# UNITED STATES PATENT AND TRADEMARK OFFICE

APPLICATION NO.	FILING DATE	FIRST NAMED INVENTOR	ATTORNEY DOCKET NO.	CONFIRMATION NO.
10/583,938	09/01/2006	Sebastien Bardon	0543-1009	4642

<b>Office Action Summary</b>	<b>Application No.</b> 10/583,938	<b>Applicant(s)</b> BARDON ET AL.	
	<b>Examiner</b> ANTHONY SHUMATE	<b>Art Unit</b> 1775

Fig. 4

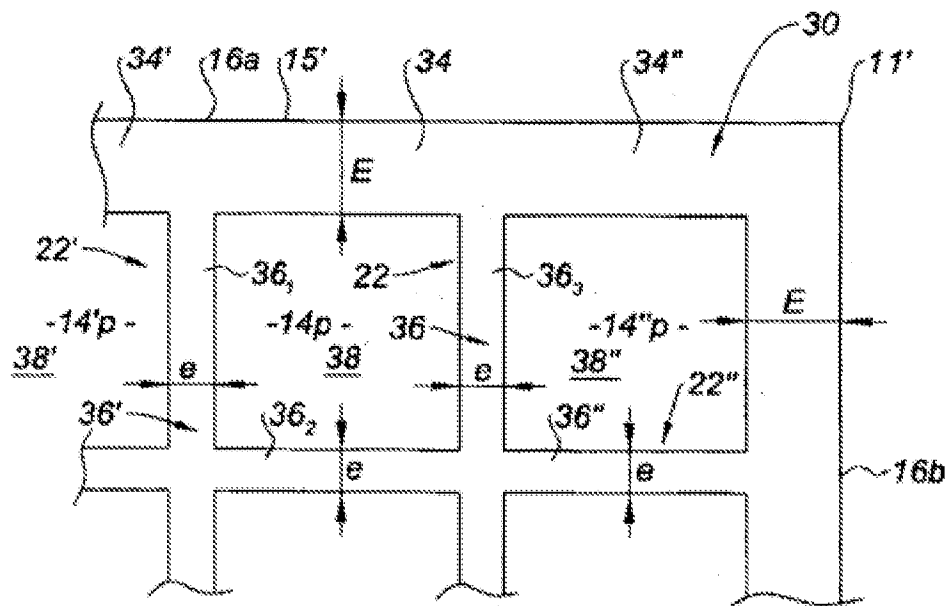
The Examiner notes the instant figure 4,

Also for instant claim 18, HASHIMOTO teaches particularly at the figures wherein the transverse cross-section of the channels is not square shaped.

Also for instant claim 18, HASHIMOTO teaches particularly at figure 5 and column 5 lines 22-33 wherein the first portion comprises an external face defining an exterior of the block.

Also for instant claim 18, HASHIMOTO teaches particularly at figure 5 wherein the thickness of internal portions of the side walls of peripheral channels of said blocks is identical to a thickness of walls of internal channels of the blocks.

FIG. 5

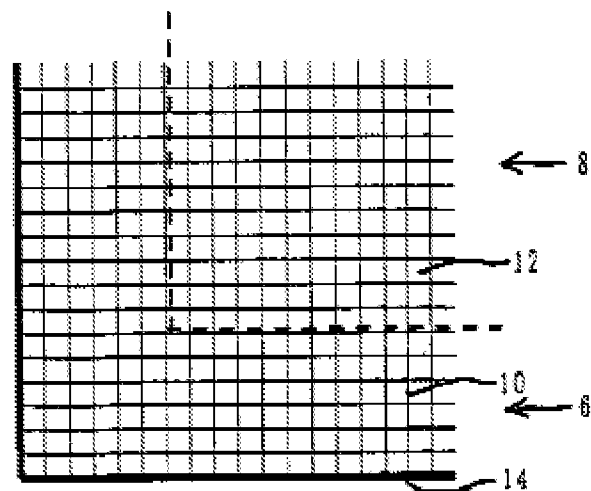
and figure 5 of HASHIMOTO

For instant claim 22, HASHIMOTO teaches particularly at figure 5 and column 5 lines 22-33 wherein channels with the reinforcement (14) (i.e. the reinforced channels of the group) are arranged so that the reinforcing partition (14) overlaps a longitudinal edge of the filter block (2).

For instant claim 23, HASHIMOTO teaches particularly at figure 5 and column 5 lines 22-33 wherein channels with the reinforcement (14) (i.e. the group of reinforced channels) comprises all peripheral channels of the block (2) so that the reinforcing partition surrounds the block (2), so that the reinforcing partition (14) is at an external surface of the block (2).
